CTC + AAC BP07 Core & Shell Group 2

ADDENDUM #1

## Addendum #01

| Project | UK CTC BP-07 Core and Shell Group 2 | UK Project #       | 2563.0     |

9 PLAN DETAIL - CONNECTOR CURTAIN @ PARKING GARAGE WALL  
1 1/2" = 1'-0"  
1/A201.C

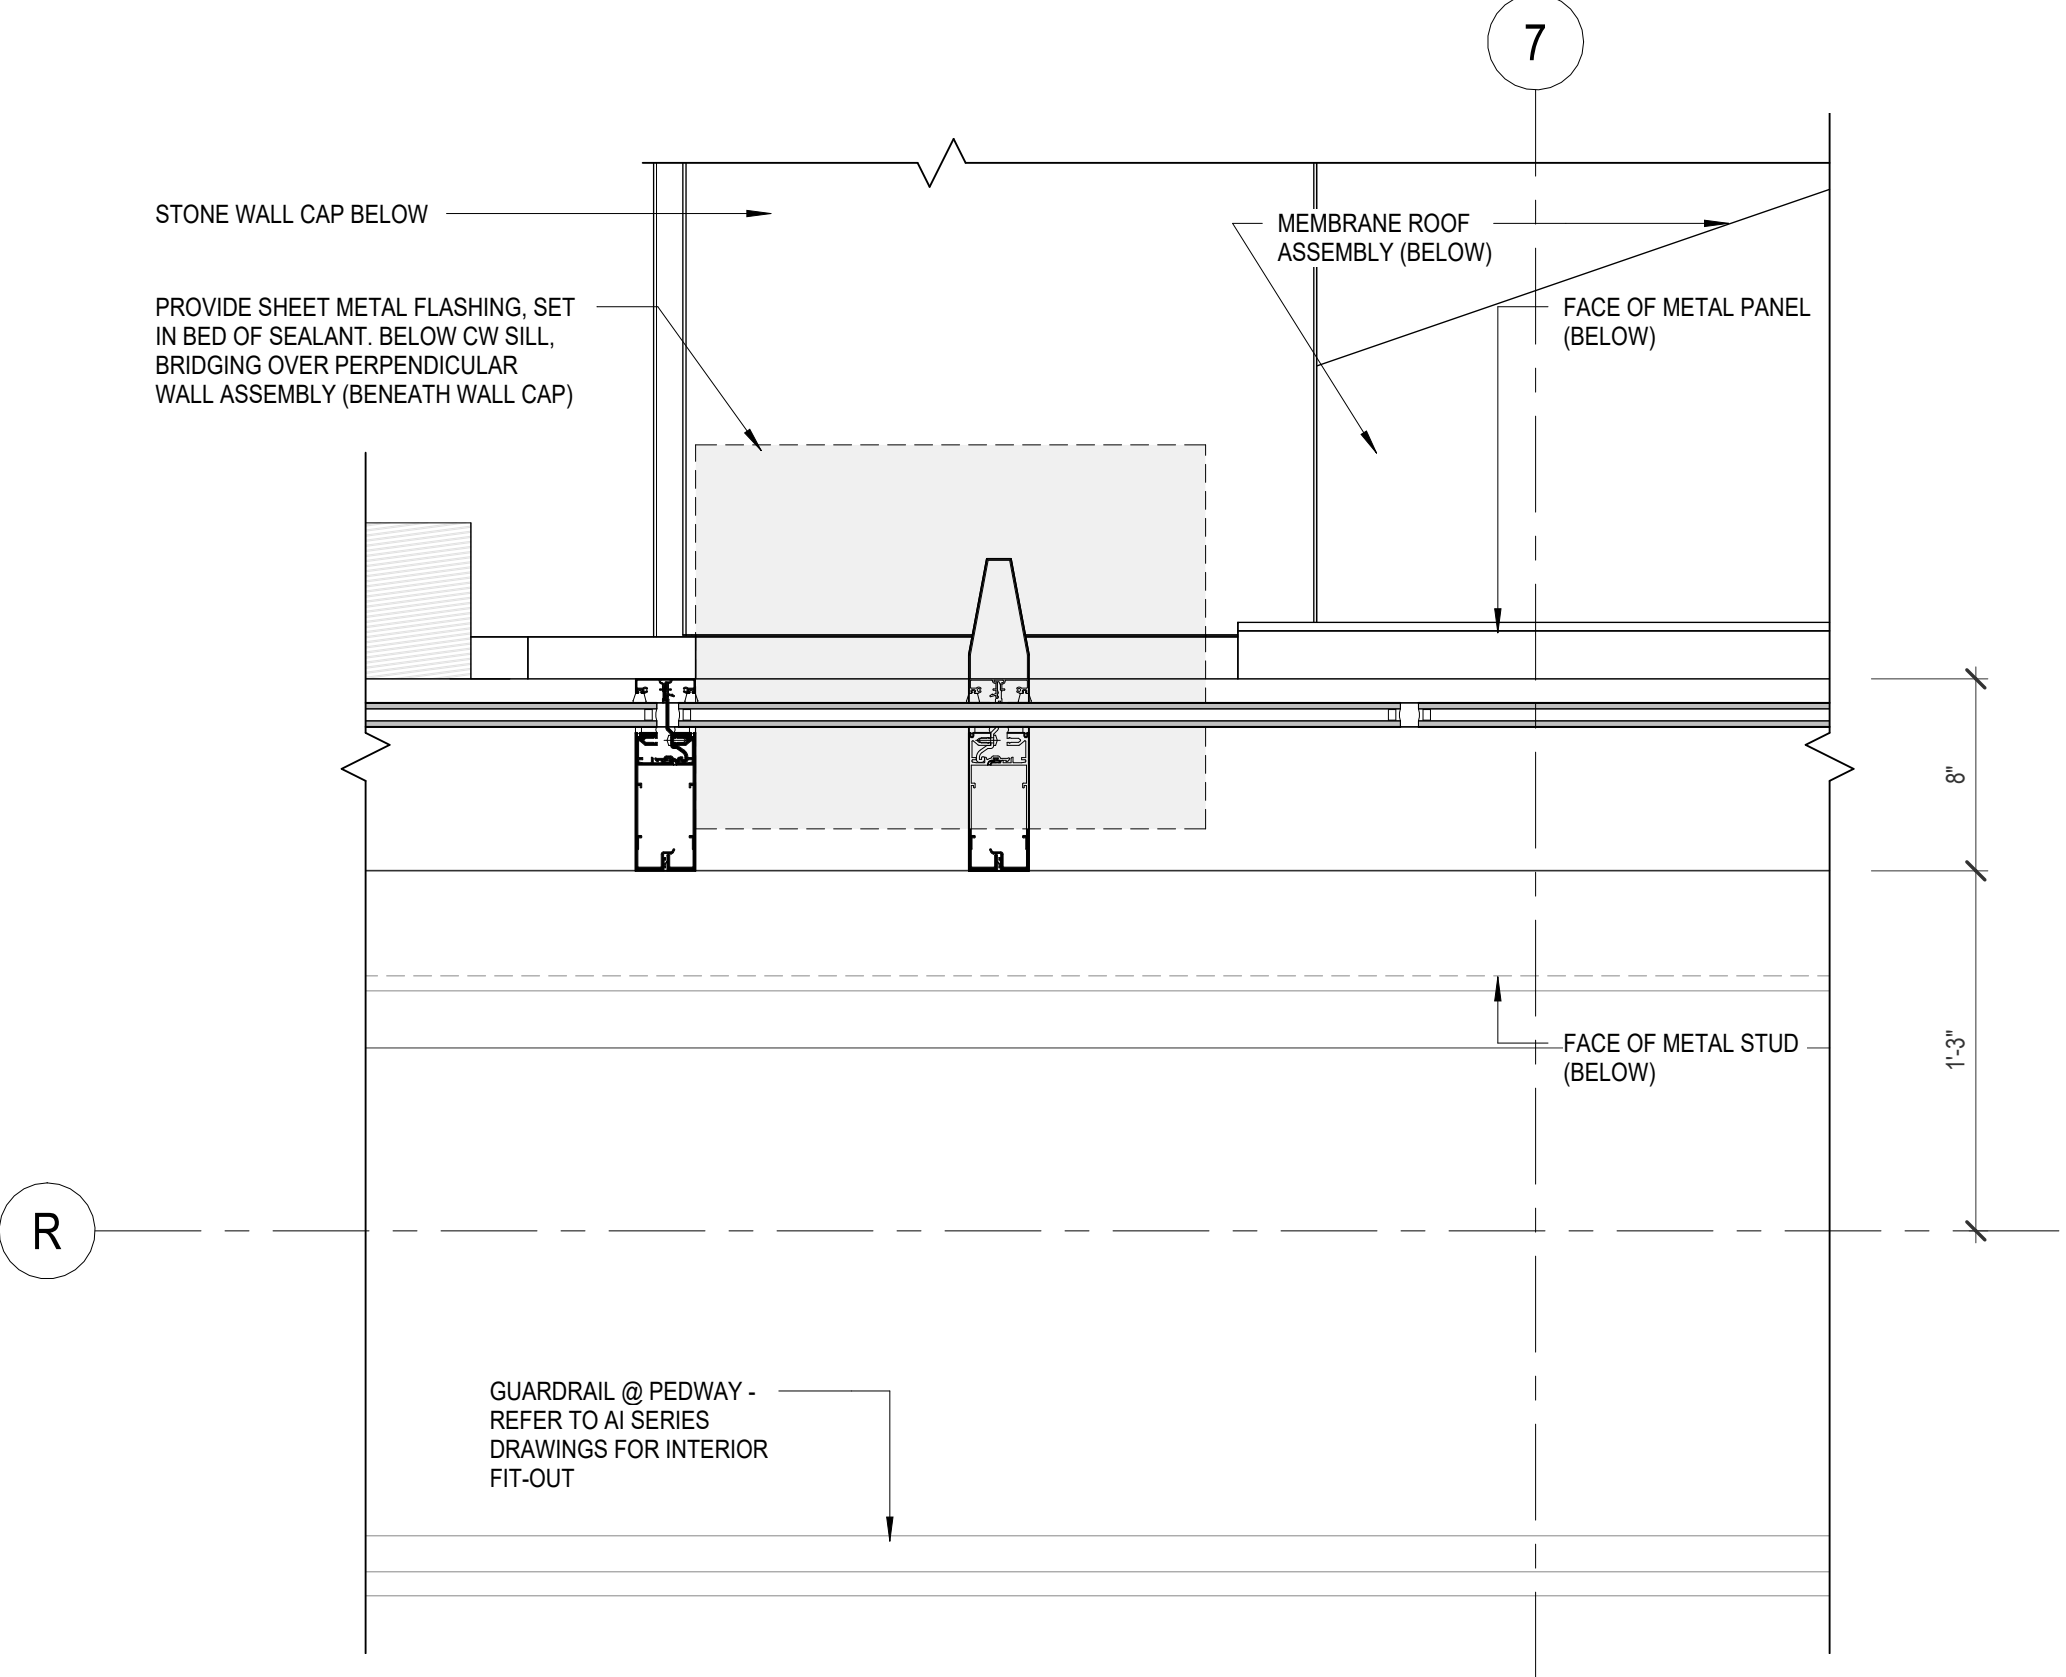
**A473.A – EXTERIOR PLAN DETAILS**

1. Revise detail 9 to coordinate with fire wall in parking garage project.
